PLANT NAME: St. Lucie Unit No. 1  
RJL 12/6/77

December 1, 1977  
L-77-360

Re: St. Lucie Unit 1  
Docket No. 50-335  
Inservice Inspection Program

Your letter of September 12, 1977 requested additional information on our proposed inservice inspection program for St. Lucie Unit 1. The information you requested is attached.

FIGURE 16. THE REACTOR PRESSURE VESSEL CLOSURE HEAD ON ITS STAND AT ST. LUCIE PLANT UNIT 1

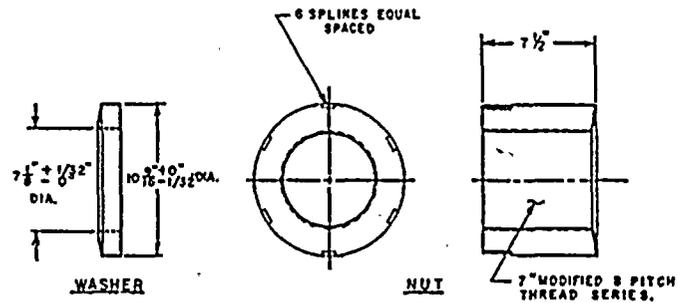
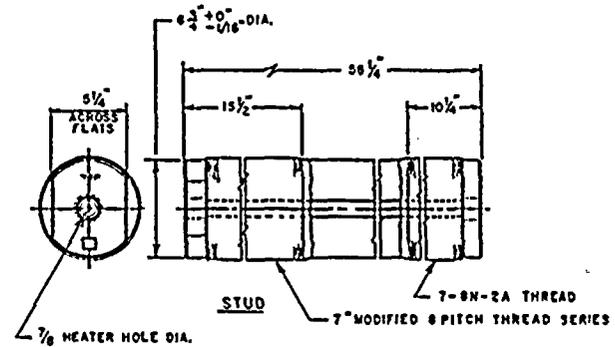
Question 1: Provide a detailed explanation of the inaccessibility of the reactor pressure vessel (RPV) closure head dome welds (item no. Bl.2) which prevent the required volumetric examination. Provide the radiation level expected at this location. Also, discuss any other forms of inservice inspection you have considered and the reasons they were considered impractical.

Answer: The RPV closure head dome weld and a portion of each of the meridional welds are not accessible from the outside surface (OD) due to the cooling plenum and the cluster of control rod drive mechanisms being in place. This can be visualized when reference is made to Volume I, Page 520, Figure 16 of the St. Lucie Plant Unit 1 Preservice Examination (PSI) Report. In addition, the configuration of the area is such that the control rod drive and instrumentation penetrations obstruct examinations from both the inside surface (ID) and the OD. (See Volume II, Appendix A, Figure A-6 of the PSI Report).

Experience from similar reactors indicates that the radiation levels to be expected under the RPV closure head are of the magnitude of 5 R/hr, and over. On the OD these fields are reduced drastically and experience shows that a range of 20 to 50 mR/hr is the amount of radiation to be expected.

Volumetric examination (ID and/or OD) by either ultrasonic (UT) or radiography (RT) techniques is not only impractical but also inconclusive. Even if accessibility and radiation levels were permitting, the amount of the RPV closure head dome weld that can be examined is minimum and cannot meet Section XI of the ASME Code requirements due to the configuration of the area.

Surface examination of the RPV closure head dome weld from the OD cannot be performed by either magnetic particle (MT) or liquid penetrant (PT) techniques for reasons of inaccessibility and impracticability of removing the protective paint coating of the closure head (if accessibility was such that the examinations could be performed). From the ID, MT cannot be performed due to the stainless steel cladding and PT is limited to a very small portion of the weld due to the configuration of the area. This limited examination by PT techniques from the ID of the closure head is considered impractical because it cannot be performed without undue radiation exposure to the examination personnel.

FIGURE 1

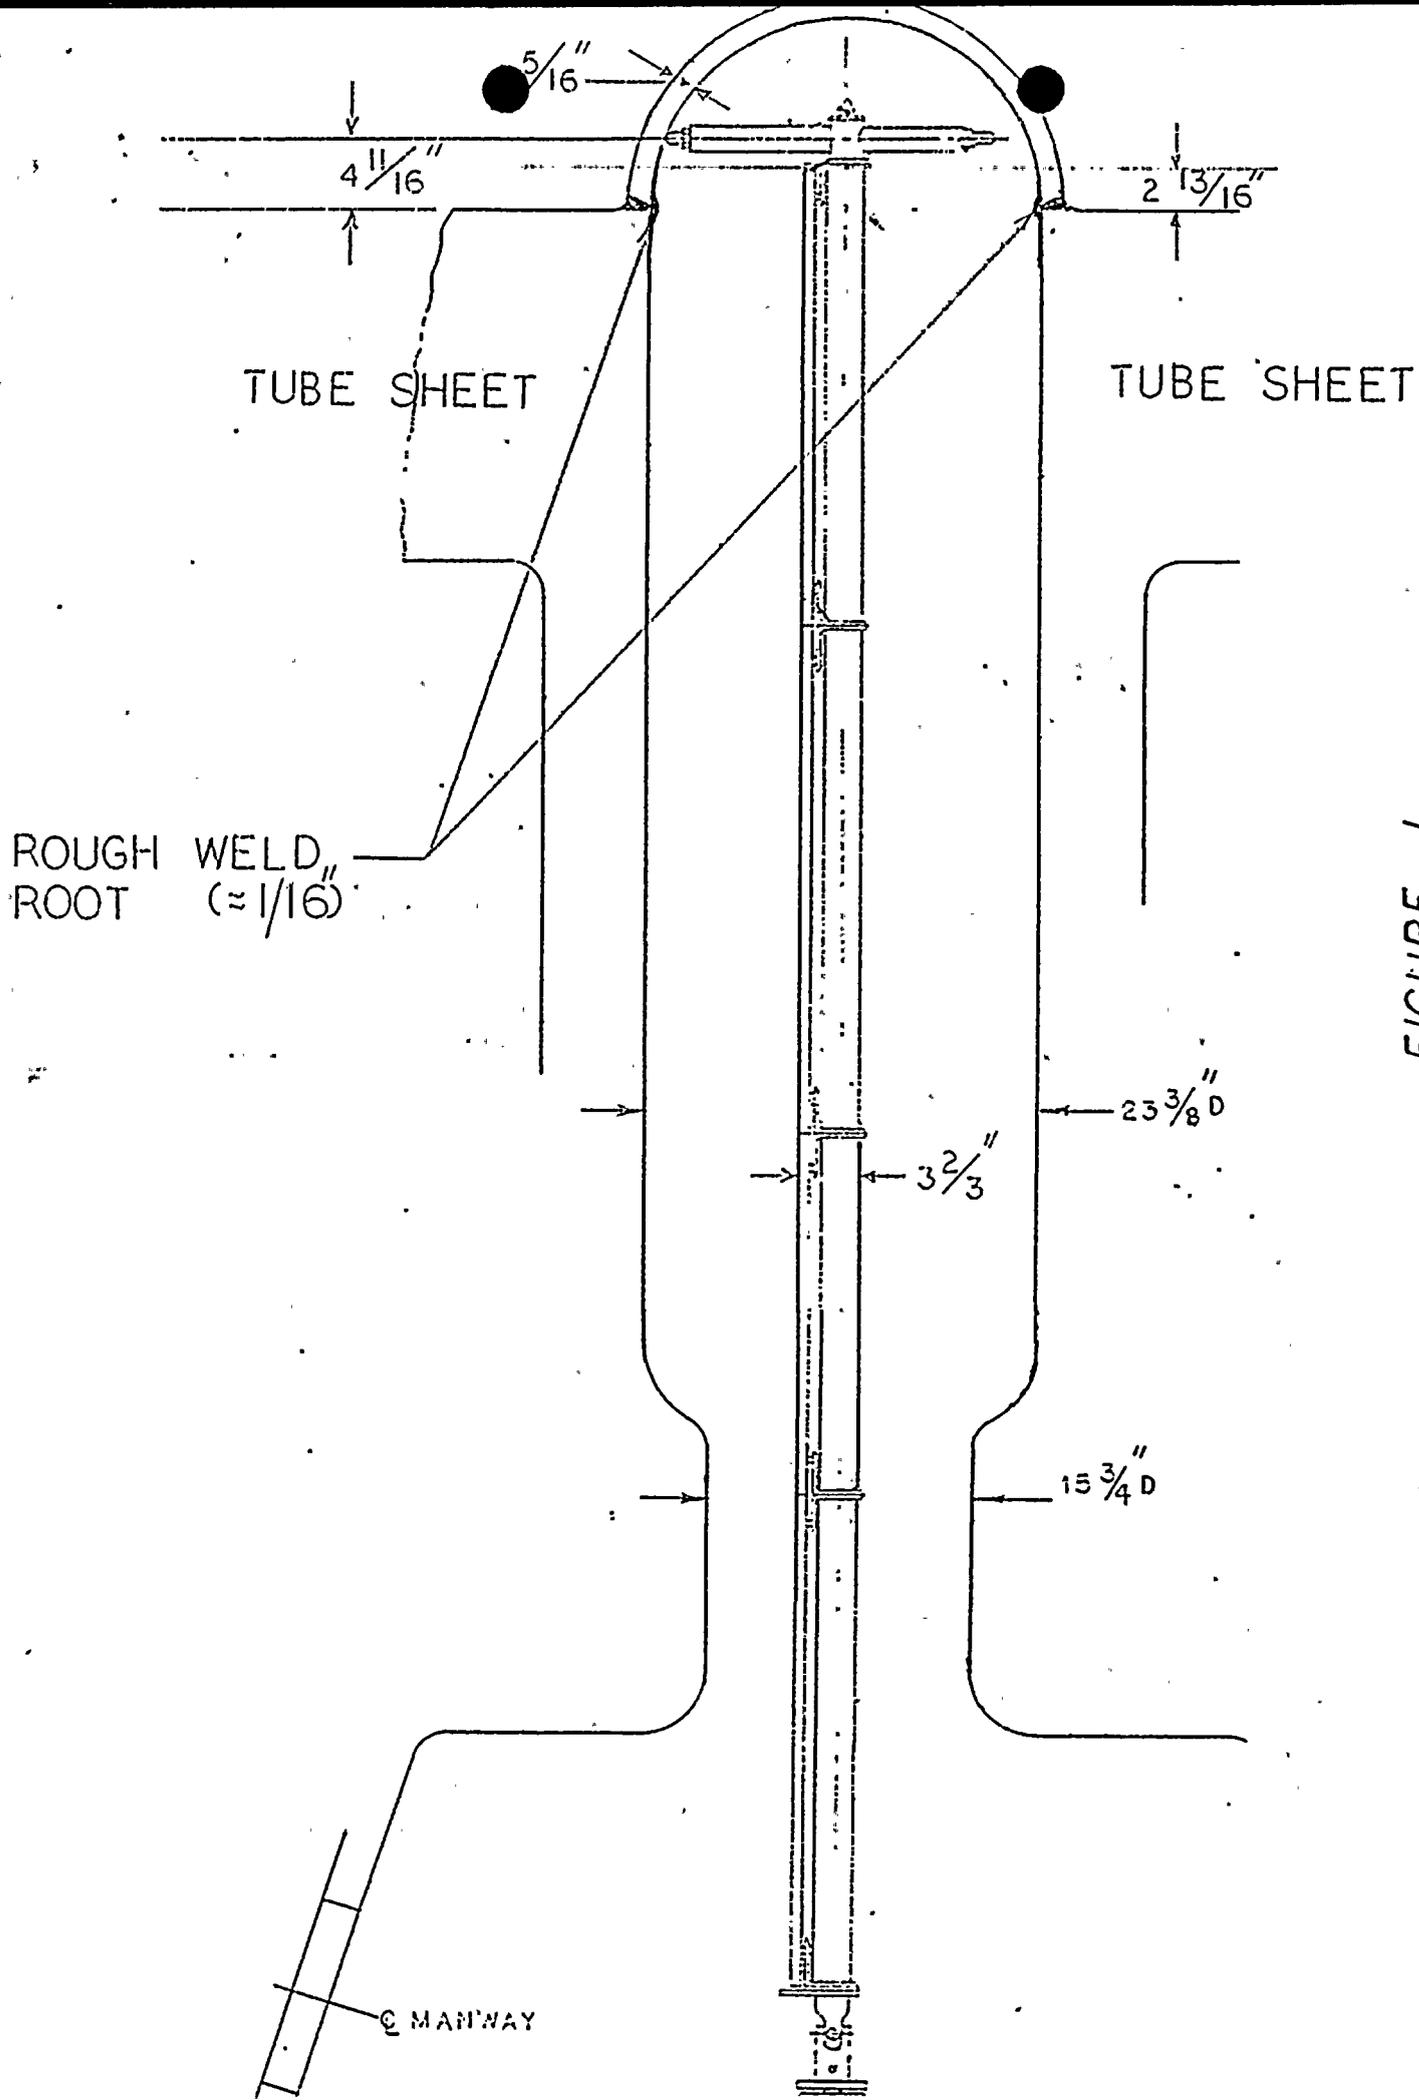
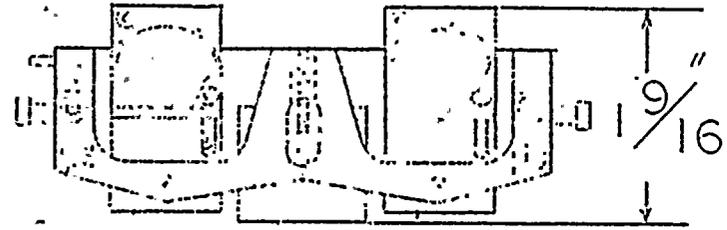
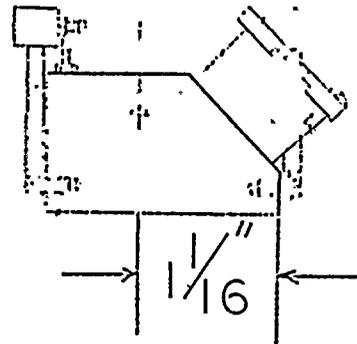
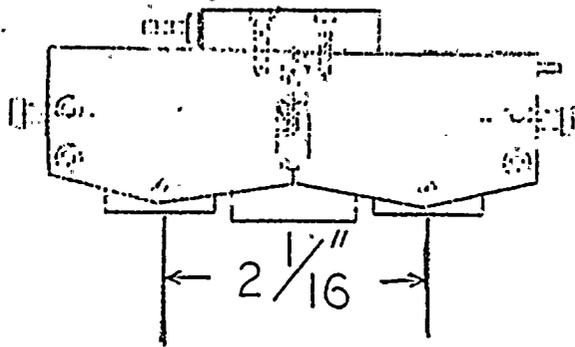
Question 7: Explain in detail why the configuration of the staywell dome-to-staywell cylinder welds in both steam generators (1A and 1B) prohibit a meaningful examination for both ultrasonic and radiographic techniques. Discuss why any alternate form of examination, such as surface examination, cannot be used in lieu of the required volumetric examination.

Answer: The staywell dome-to-staywell cylinder weld in both steam generators, due to its geometry and accessibility, is not conducive to any meaningful examination. Figure 1 shows the configuration of the staywell, the staywell dome-to-staywell cylinder weld, the permanent track installation, and specific dimensions as measured in the field during the PSI examinations. Figure 2 shows the transducer module configuration and dimensions.

As it can be seen in Figure 1, the clearance between the ultimate stop of the device is located  $2-13/16$  inches above the weld. The transducer module is  $1-9/16$  inches deep, therefore, ideally there is a clearance of  $1-1/4$  inch of area that can be examined. When we apply a safety factor of  $1/2$  inch, in order for the module to operate freely, the area scan is reduced to only  $3/4$  inch. But the incident point of the transducer beam is located  $1-1/16$  inch from the end of the shoe, so the beam in reality is not scanning the weld but only the tube sheet. This is a meaningless examination.

In the transverse configuration of the module there is the  $3/4$  inch area of base metal that ideally can be examined. But the root of the weld is not a smooth area and, therefore, the transducer module cannot ride over the weld smoothly. Hence, the examination is obstructed by this factor, and also by the curvature of the staywell cylinder dome.

An attempt to cover the weld from its bottom side will not be successful due to the tube sheet thickness. The beam cannot be bounced on a back wall to cover the root of the weld and again due to the area geometry only partial scanning of the weld crown and approximately the upper third of the weld can be performed. Of course, transverse examination is useless due to the tube sheet thickness and tube configurations.

Therefore, the UT examination of this weld cannot meet Code requirements and the limited examination that can be performed is not enough to produce any meaningful or conclusive results.

Radiography, surface, or visual examinations cannot be performed due to inaccessibility of the weld because of the stationary track installed for the UT examinations of the rest of the staywell cylinder welds.
